SUNDRY NOTICES AND REPORTS ON WELLS
Do not use this form for proposals to drill or to re-enter an abandoned well. Use Form 3160-3 (APD) for such proposals.

8. Well Name and No.
Cities Fed #4

9. API Well No.
30-025-26089

Southwest Royalties

BEFORE PLA

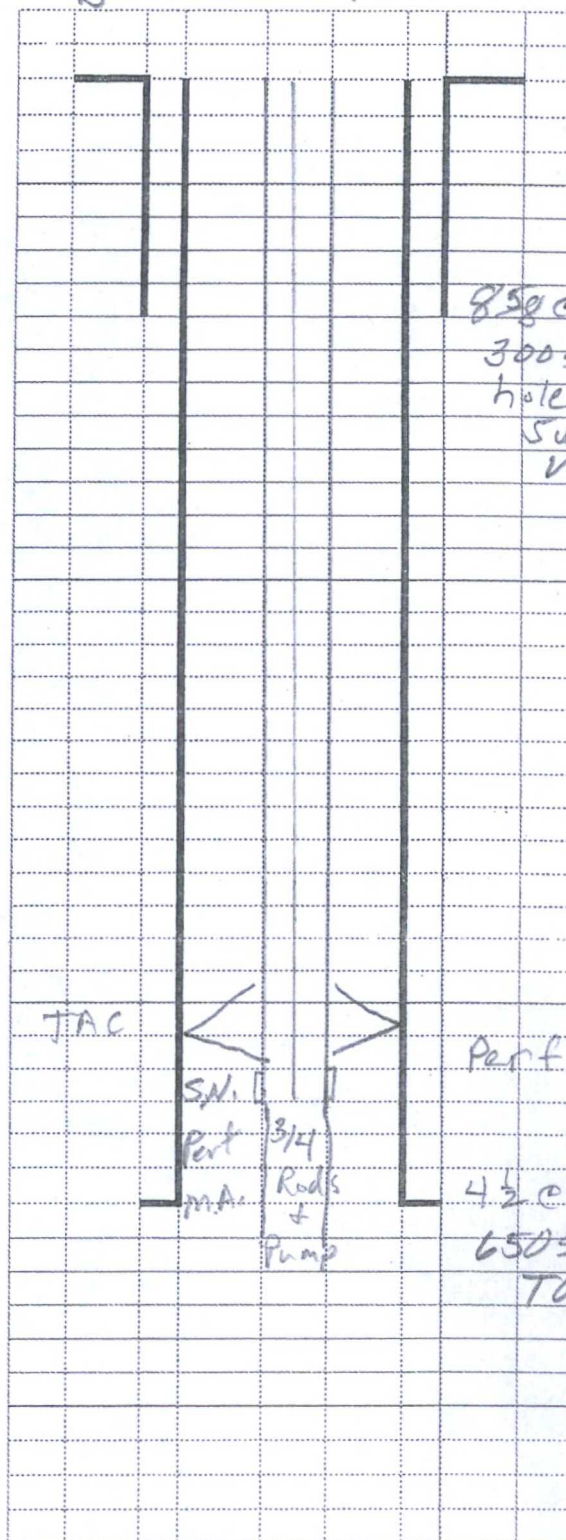
Below ground abandonment marker Required - See COA
Closed Loop System P&A mud between all plugs.

PLS @ 5/19
 Cement to
 surf
 w/ 1405K
 Verify
 Visual

PLS NO SX
1297
1400'-1307
WOC+TAG

15
15SX
CIBP @ 3200'
W/15SX
